Public Works (1897) Department.

G.O., No. 530 W

Transferring, with remarks,
to the P. W. D. B. P. reporting that
the construction of a mud wall
round the Collector's Office, Trichi-
-nopoly, may be sanctioned in lieu
of plain wire fencing.

Collector's Catchment at Diche.
- nobody: Inquiring that
plain wire fence along
South & South West boundary
of the — is useless &
suggesting that a mud wall
with tiled coping, be built

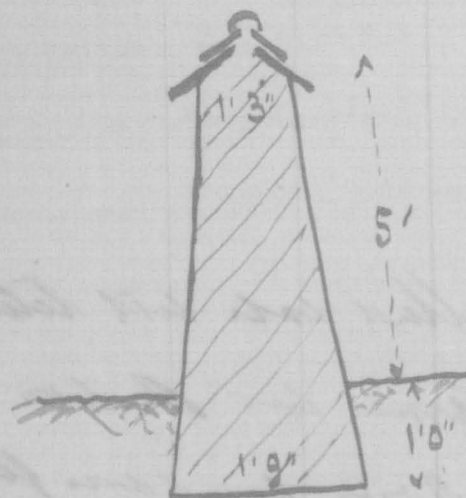
Kind walking, as per section in
margin, for a length of 1090 feet, vide
Collection letter embodied in Board's
Proceedings dated 10th July 1856 No.
3156 this will amount as under.

It is therefore submitted that mud walling is much cheaper than wire fence though it is not as neat as the latter. In regard to durability both require constant repairs & the initial cost of wire fence is almost double that of mud walling. It is thought that walling will be a more efficient barrier than a fence.

A plain mud wall would probably become shabby and unsightly after rains, and it can, it is submitted, in no way be considered a permanent structure.

The Super. Sup. VI Circle,
with reference to his letter
May 1884 J.C. D. 6 Nov-
1896. A plan & estimate
for a new wall with
a tiled coping shown
accordingly be submitted
